Penn Repair Bulletin #12

<u>April 16, 2010</u>

Sargus and Pursuit Spinning Reel Drag Knob and Spool Shaft Improvement

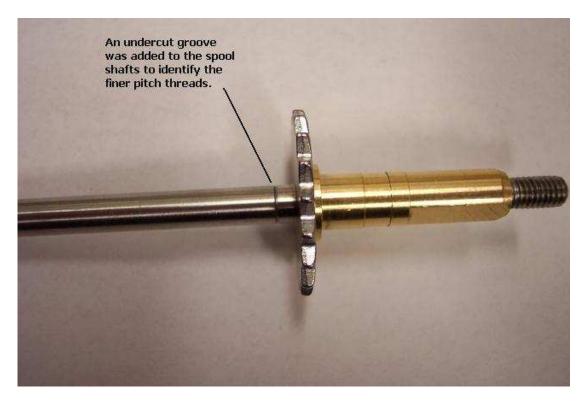
There has been a change of the thread pitch on the spool shafts, on all models of the Sargus and Pursuit spinning reels. An under cut groove under the spool shaft ratchet has been added to identify that the threads are a finer pitch. The finer pitch threads will give an improved drag adjustment to accommodate retrieves that demand a softer touch. The threads in the drag knobs have also been changed to match the threads of the spool shafts.

If the spool shaft and/or drag knob are going to be replaced it must be noted if the spool shaft has an undercut groove on it. If the spool shaft does <u>not</u> have an undercut groove on it, a new finer pitched threaded spool shaft <u>and</u> drag knob must be replaced.
